# SERVICE BULLETIN

M1560 2022-08-10

# M1560: REVOLUTION MAX STARTER CLUTCH GEAR UPDATE

Old Part No.	Item Description	New Part No.
31400109	Starter Clutch	31400109A

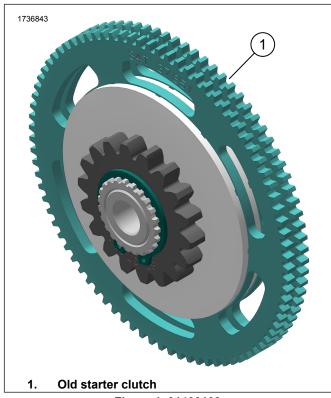
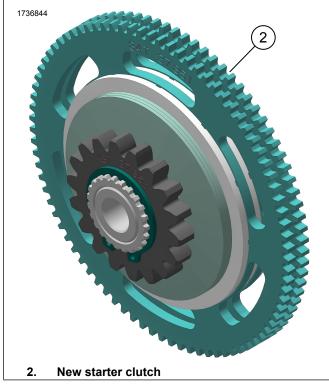
When diagnosing a starter whine condition (see Supplemental Procedure Video ), replace the starter clutch gear with (Part No. 31400109A). The updated starter clutch gear was put into production on January 13, 2022. Replacing the starter clutch gear will cure the starter whine condition only. The starter clutch gear should not be replaced to attempt a repair for any other starting concerns.

Remove starter clutch gear inventory of (Part No. 31400109) from dealer stock. File a DFS claim to remove from dealer inventory.
